Freshwater Mixed Use Development

50 Lawrence Street
Freshwater, NSW

Development Application
SEPTEMBER 2021

Sept Shadows 9am
SCALE 1:250 @ A1

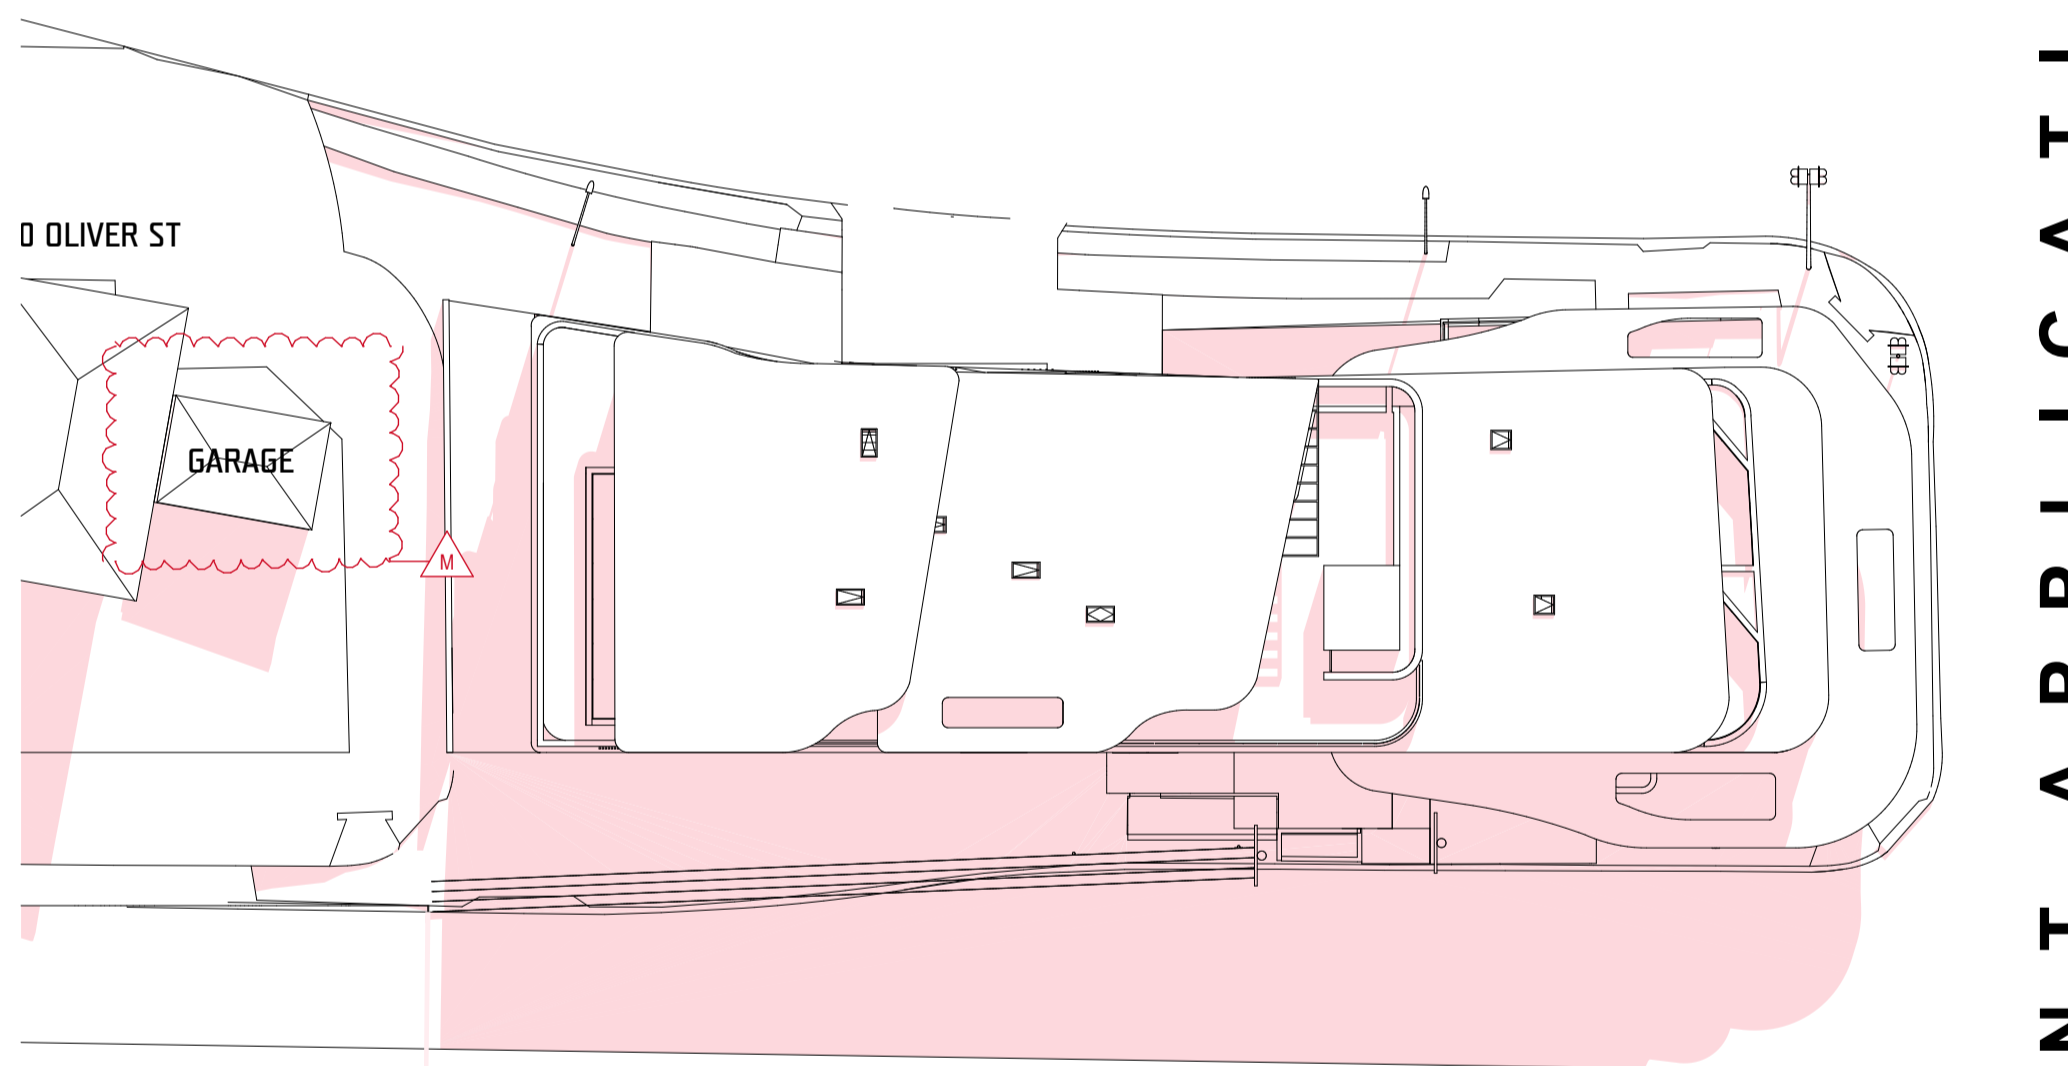
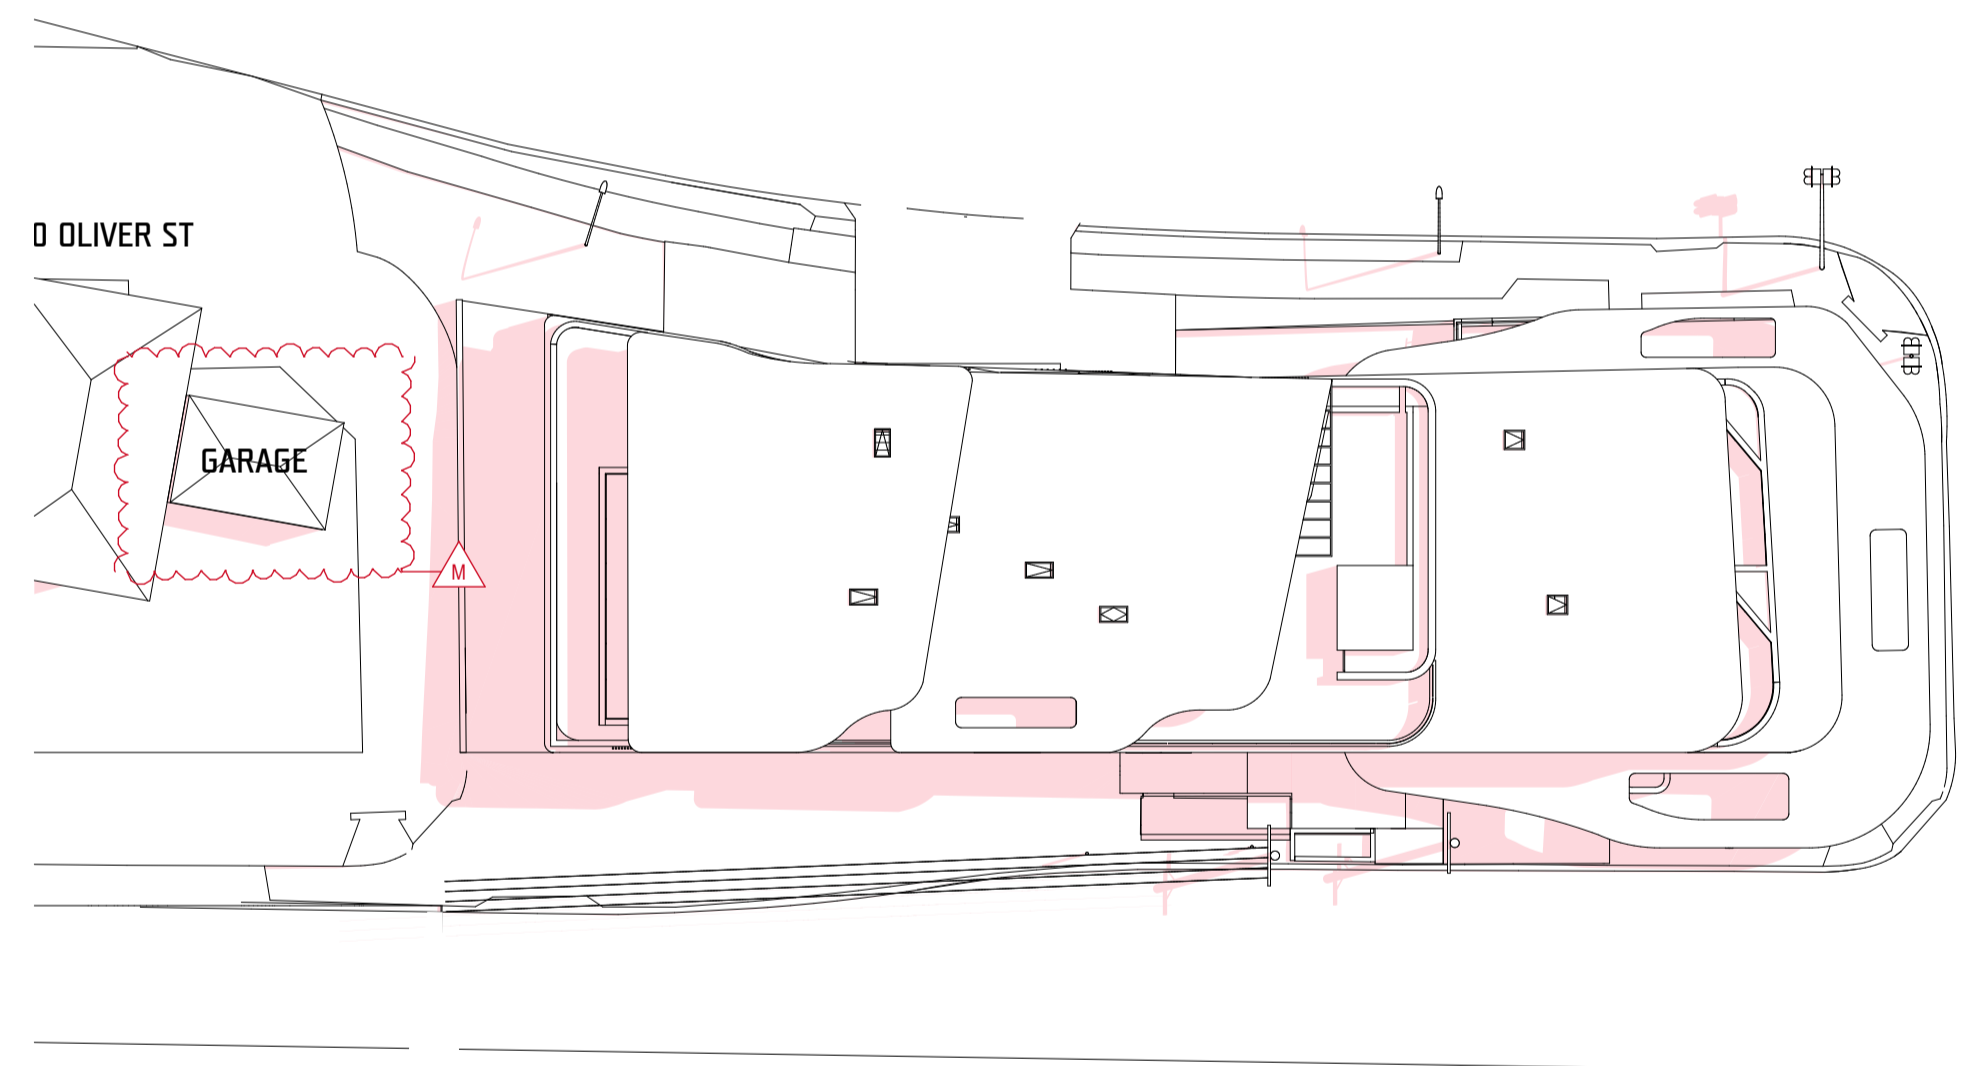
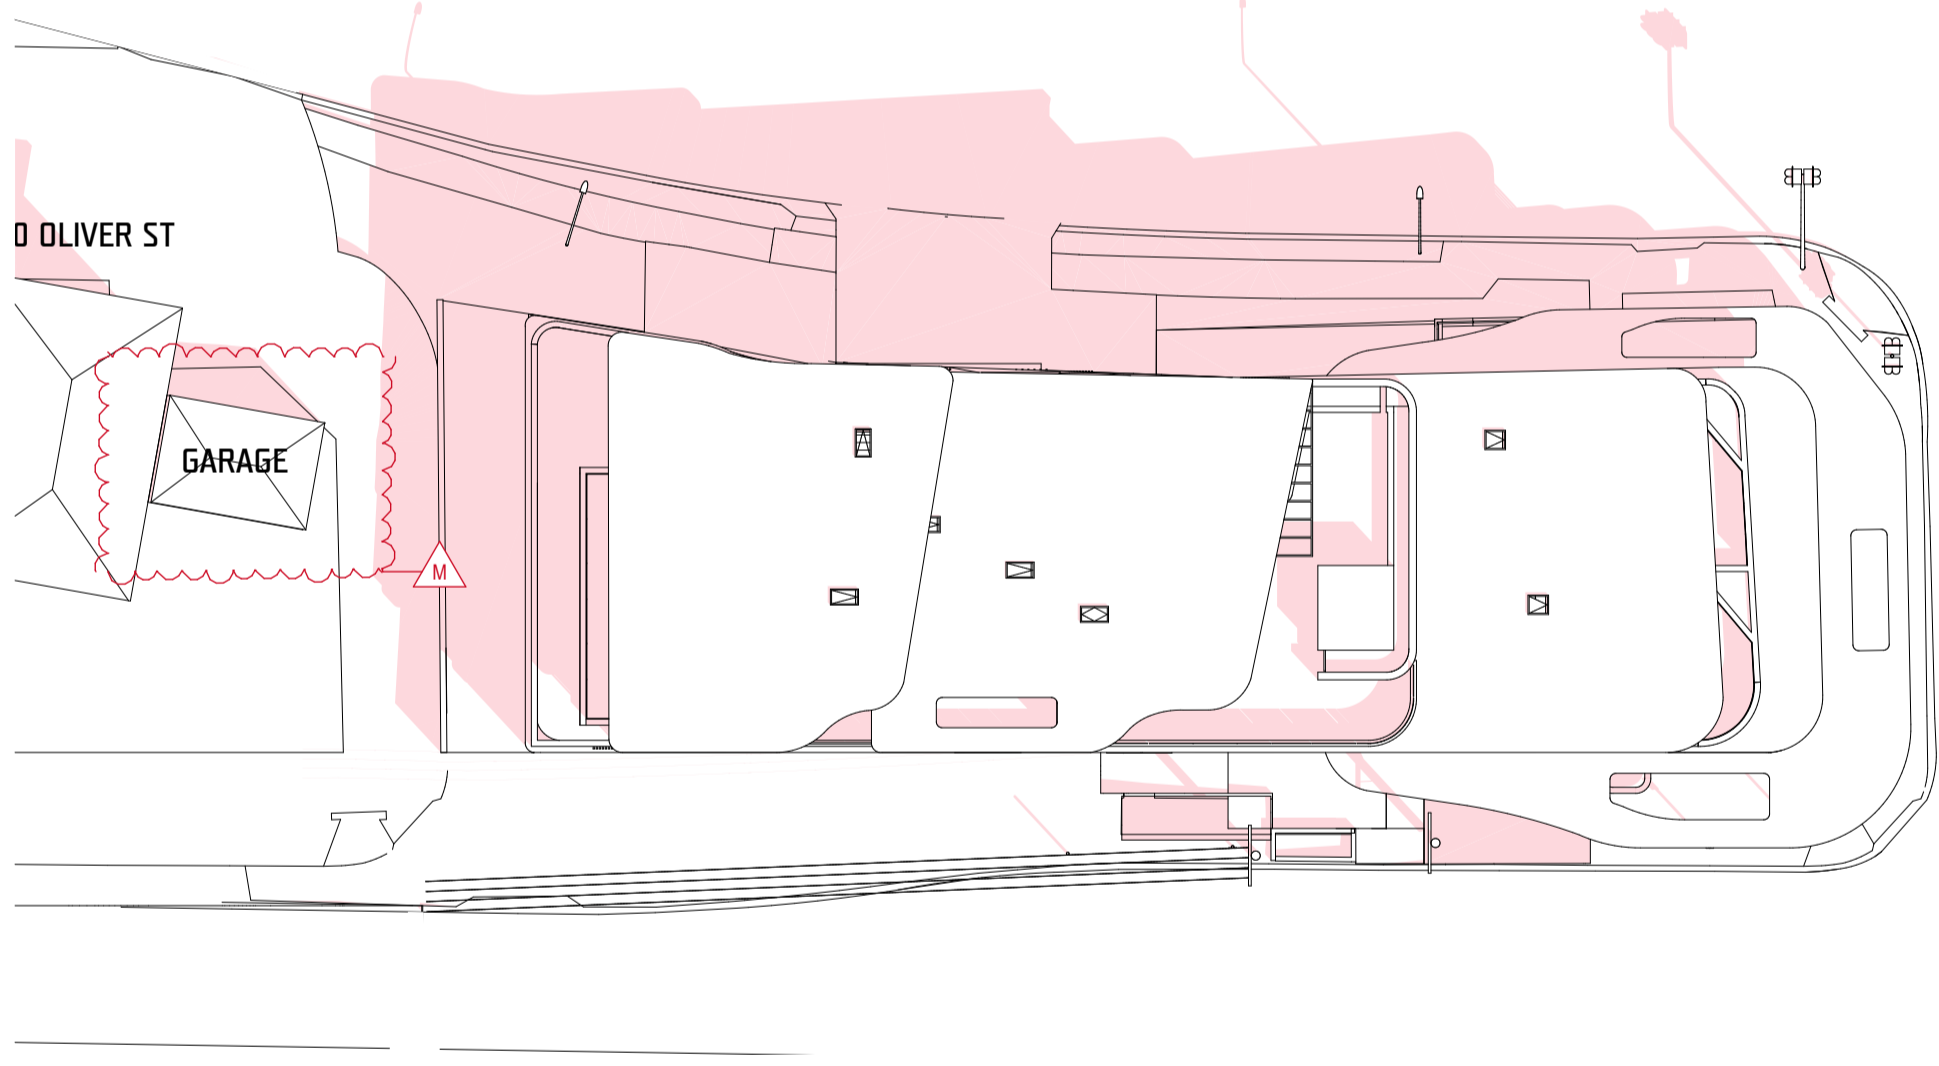
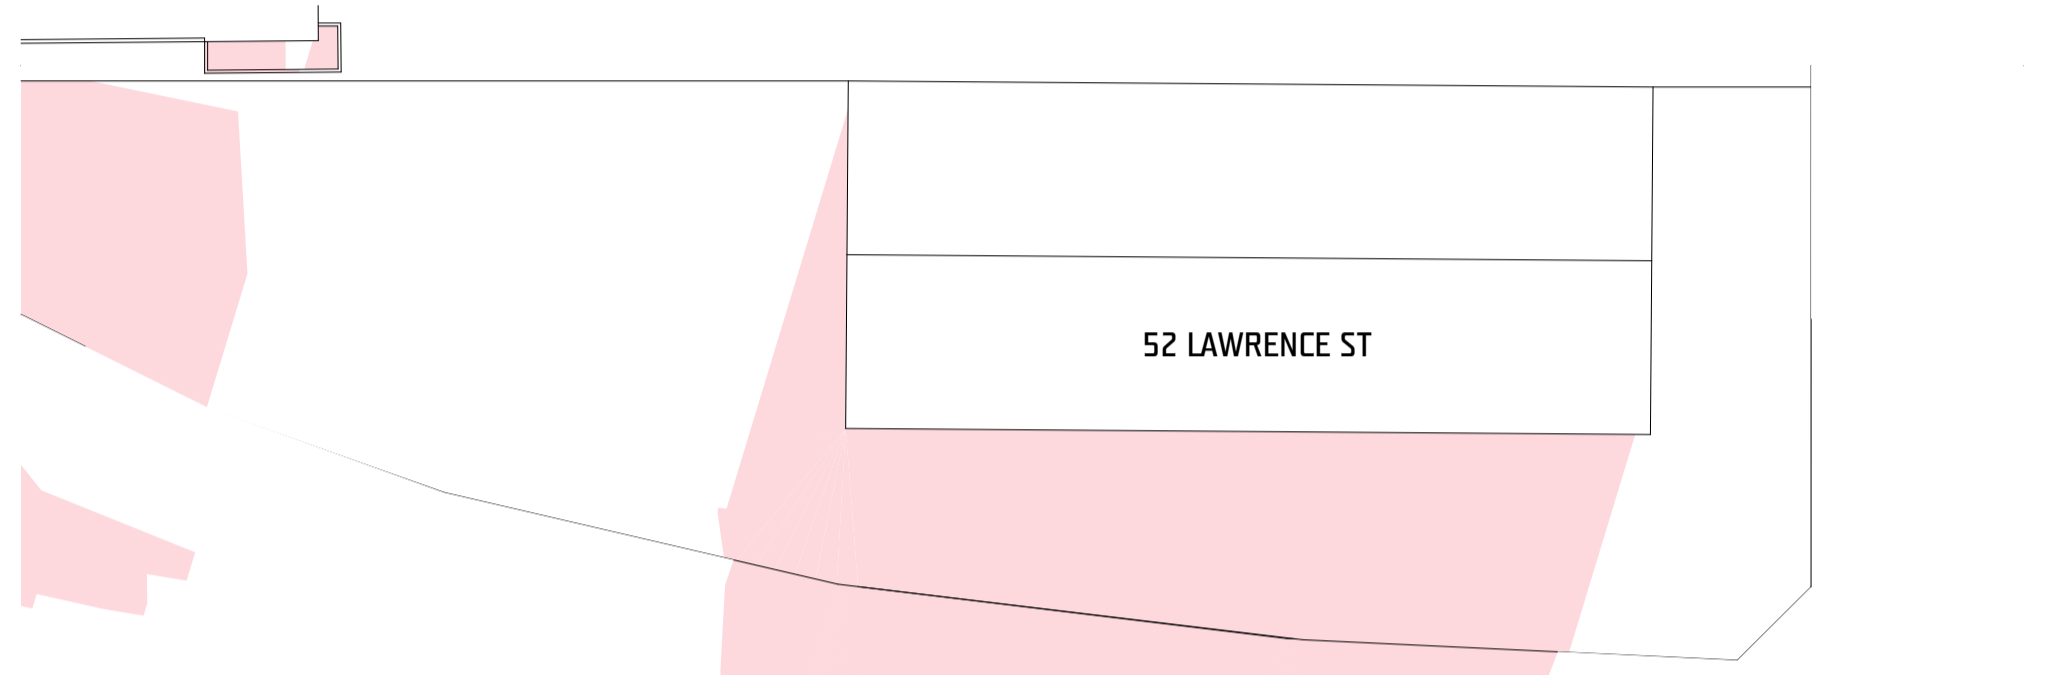
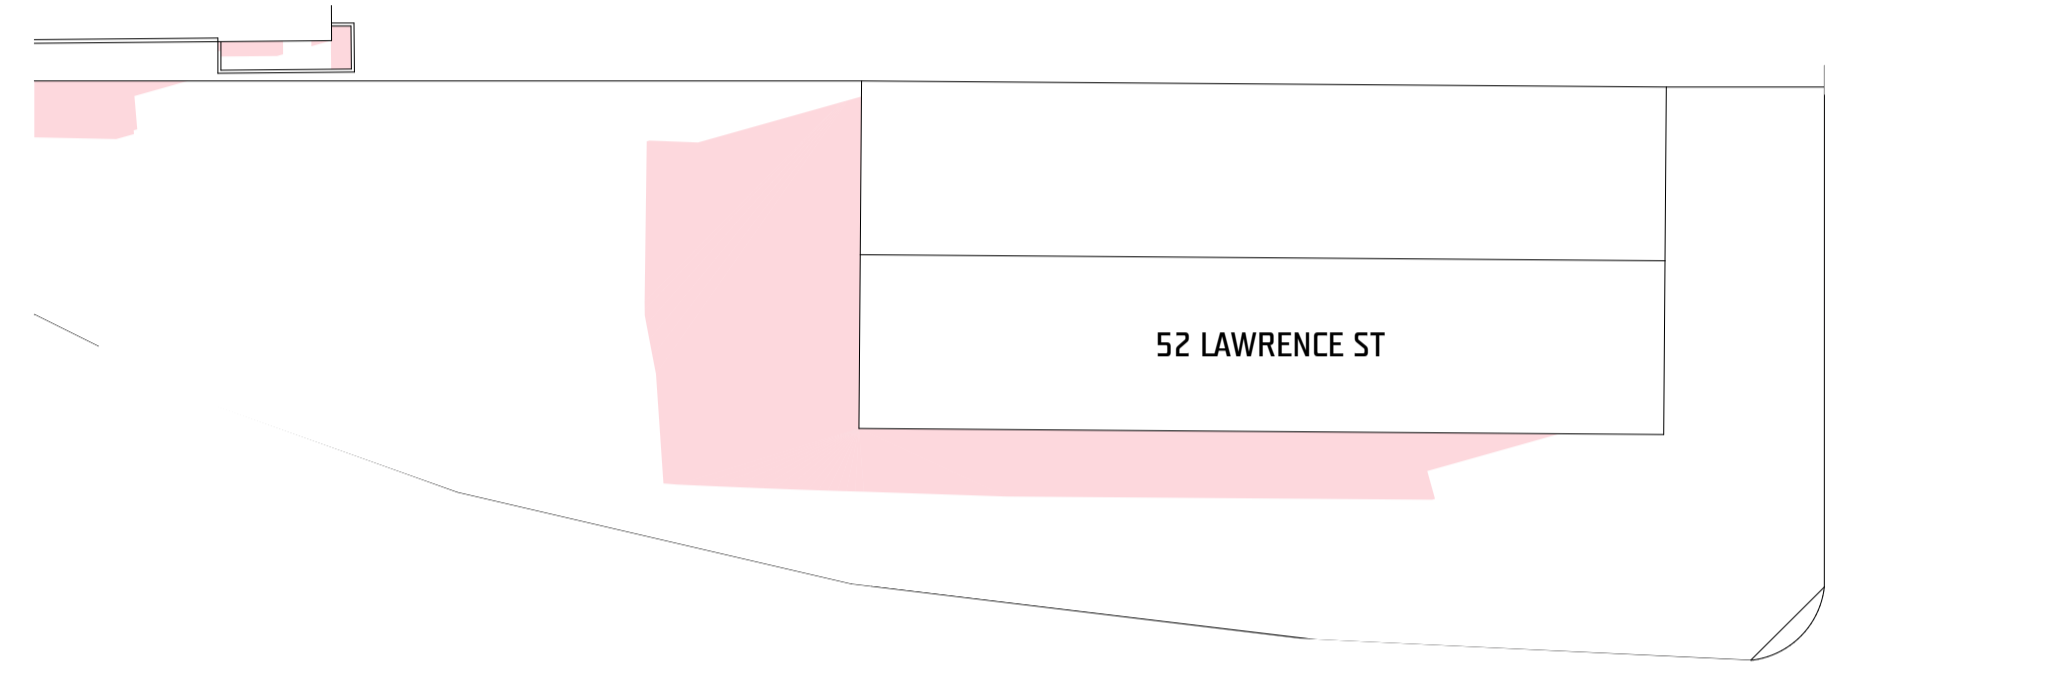
M: Neighbouring Property- Existing garage added to plans for clarity.
